## RESPONSE TO INFORMATION REQUEST

<b>Project</b>	Amazon Data Services Ireland Limited, Grange Castle South Business Park, Baldonnell Road, Dublin 22, D22 E7C9. Reg. No.: P1170-01
<b>Subject</b>	Regulation 10(2)(b)(ii) Response
<b>Date</b>	17 November 2022
<b>Ref.</b>	JG/217501.0178TR01

Figure 1.1 Water Use

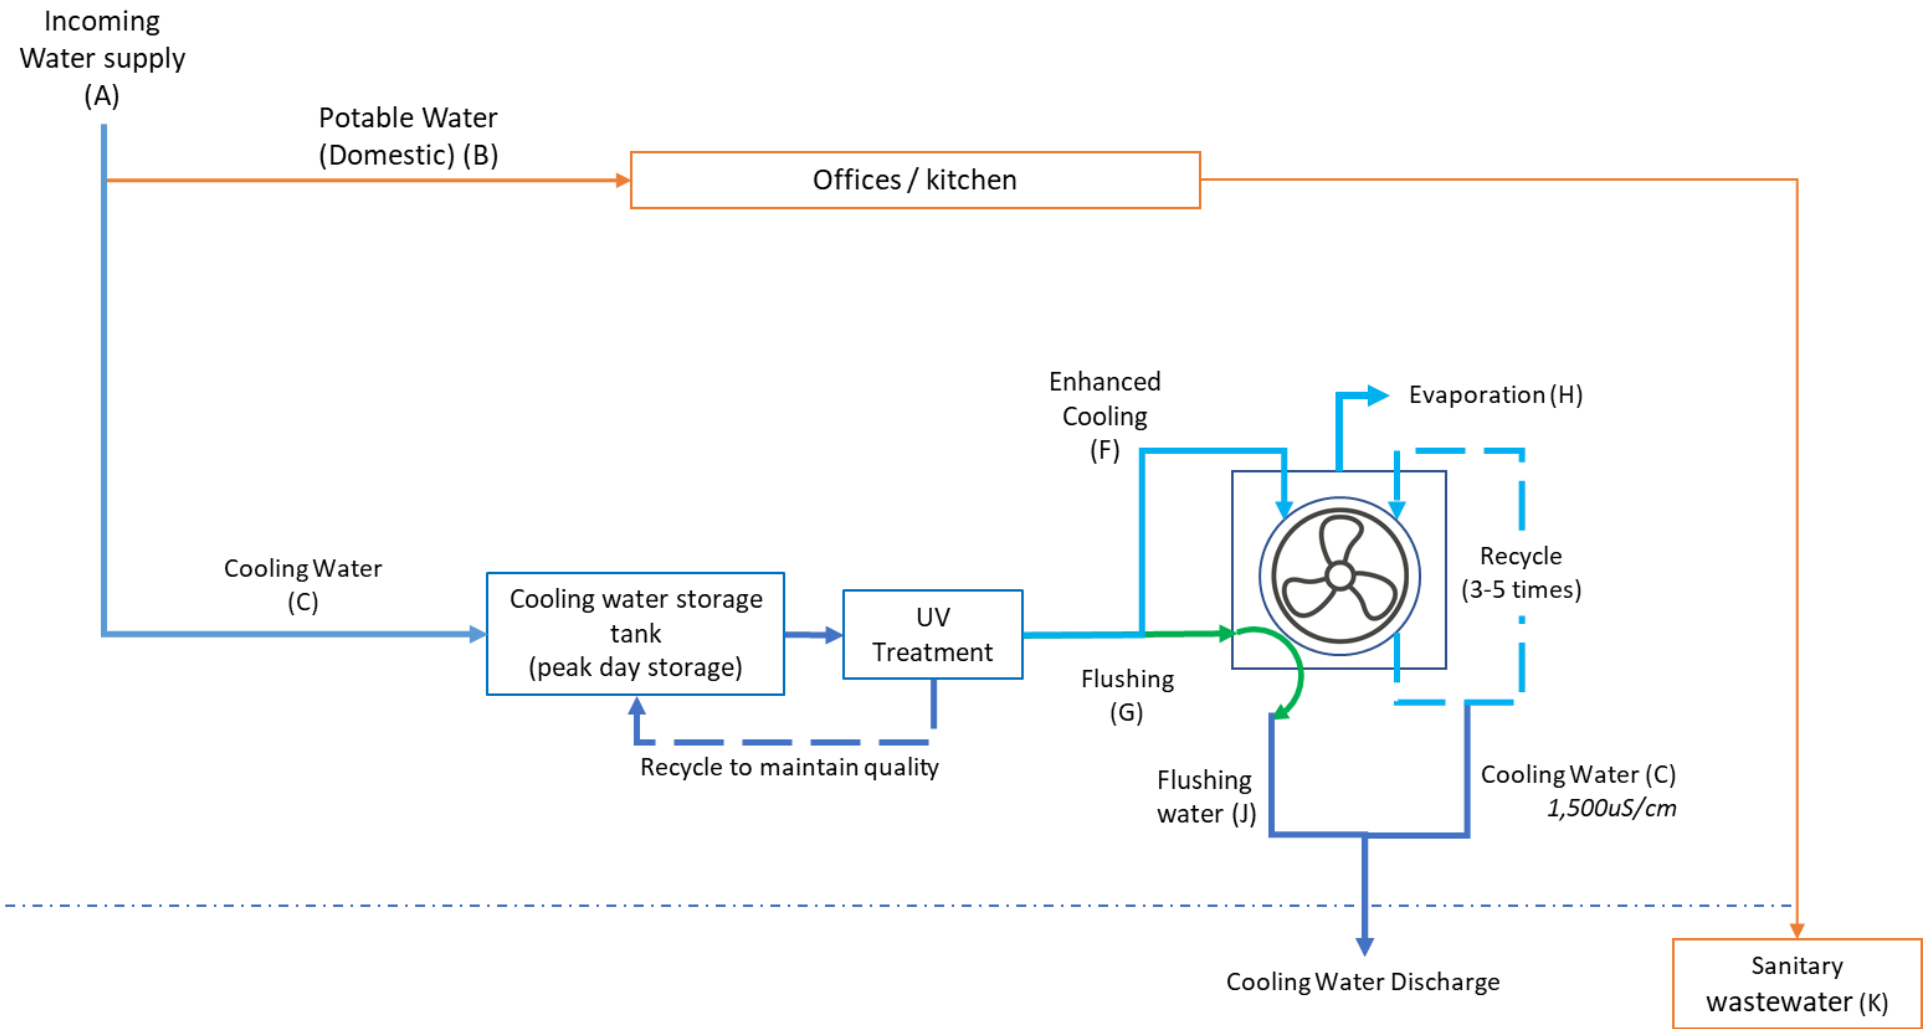
4. Provide details on how the public water supply is treated onsite prior to use as an 'evaporative cooling water'.

*Mains water is used on site for both domestic purposes (offices and kitchens) and for data hall cooling at ambient temperatures above a set point. No treatment chemicals or softeners are added to the cooling water. Prior to the cooling process water is sanitised using ultraviolet disinfection. When water is used for cooling it is recirculated in a closed loop system. Cooling water discharges typically have conductivity values between 1,200-1,500uS/cm and is discharged at ambient temperature. When a conductivity setpoint of 1,500uS/cm is reached cooling water is automatically discharged.*

*See the below process water flow diagram Figure 1.1*
